Request for Further Information under section 92(1) of the Resource Management Act 1991 (the Act) - Application Number RM10.351 by Oceana Gold (New Zealand) Limited for Various Consents Associated with Macraes Phase III

ORC Section 92 Response

Figure 8.1 Map Showing Locations of Deposited Dust Monitoring Stations

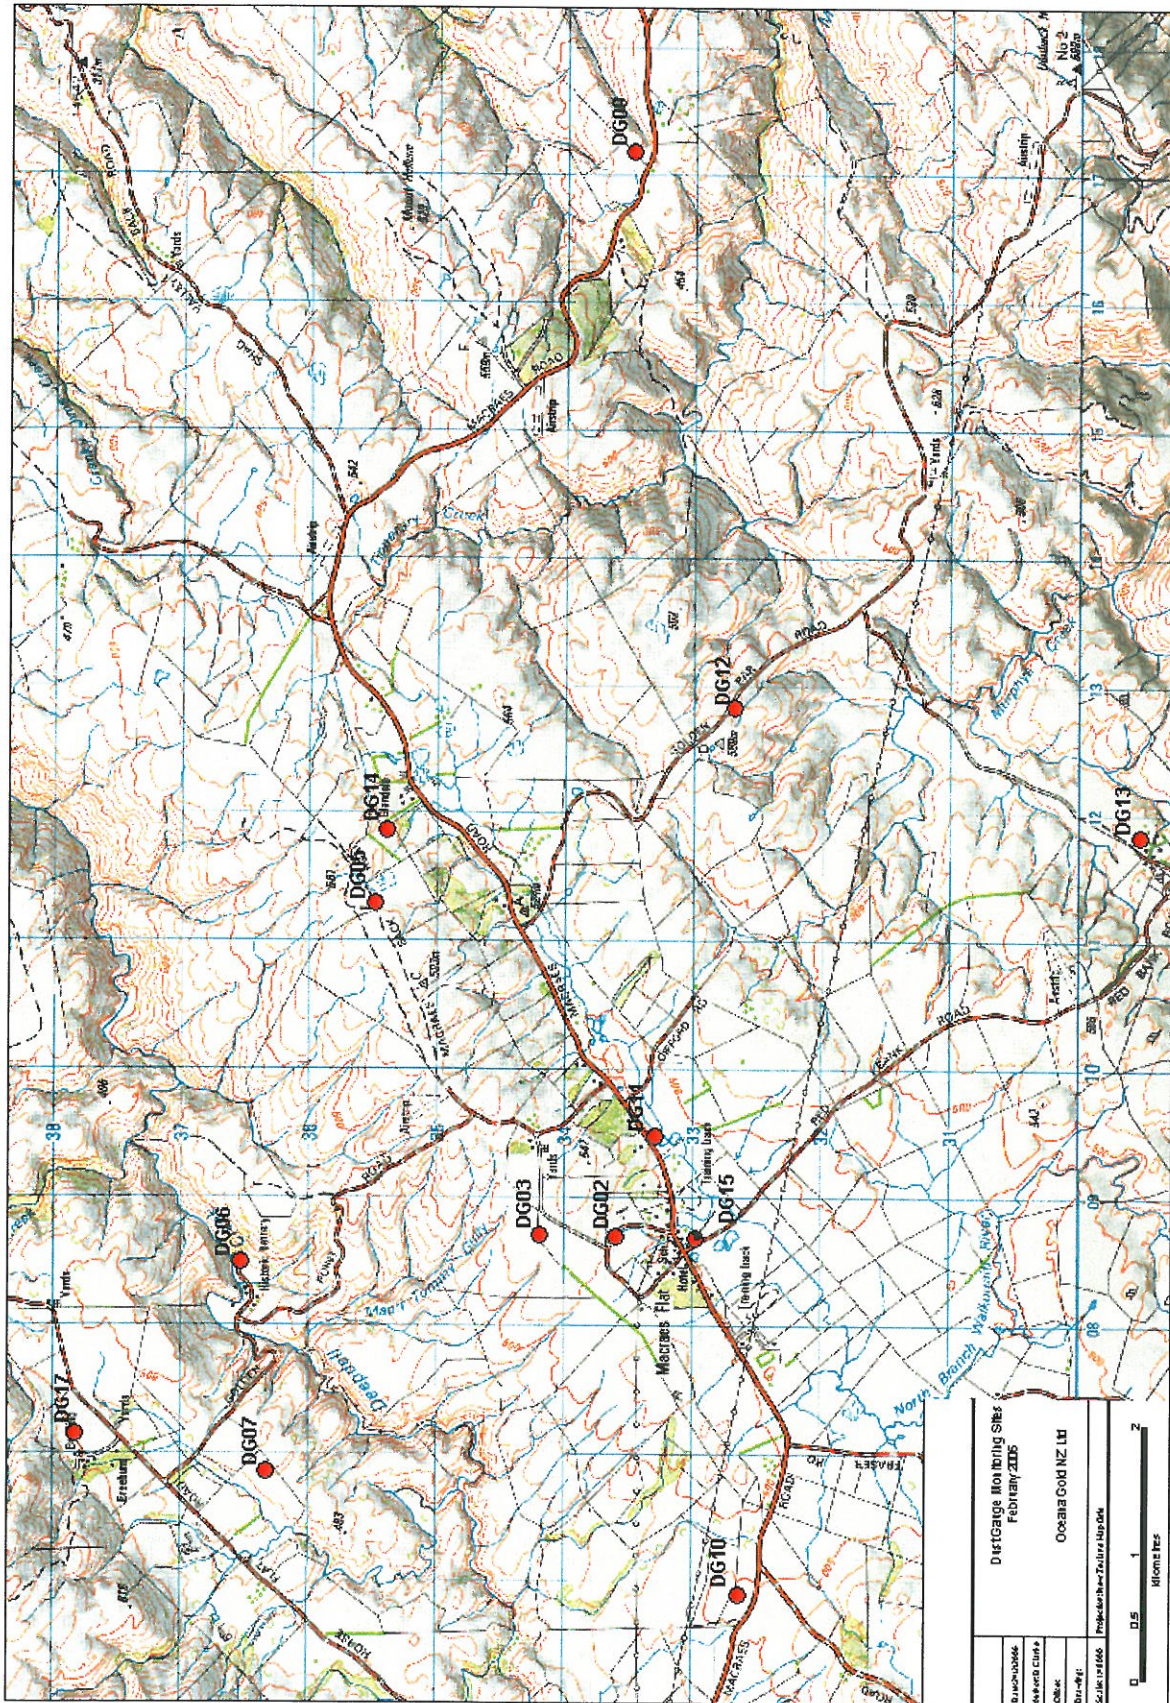
- 3) Section 10.2, on page 40 of Appendix 31, describes the proposed revised configuration of dust pots. Please confirm whether Dust Pot No.3, as shown on Figure 10.1, is the same dust pot as Dust Pot 6, as discussed in Section 10.2. Will monitoring of Dust Pot 3 be maintained in the dust monitoring regime?

Dust Pot 6 is located adjacent to the Golden Point Historic Reserve. It is proposed to remove this site from the monitoring regime and to retain Dust Pots 7 and 17 (refer Section 10.2 of Appendix 31). Dust Pot 3 is located adjacent to Golden Point Road and the Mining Offices. It is not the same site as Dust Pot 6. It is proposed to continue monitoring Dust Pot 3. Figure 8.1 of Appendix 31 shows the locations of the existing depositional dust monitoring sites. Figure 10.1 of Appendix 31 shows the proposed monitoring sites. Figures 8.1 and 10.1 are attached for reference.
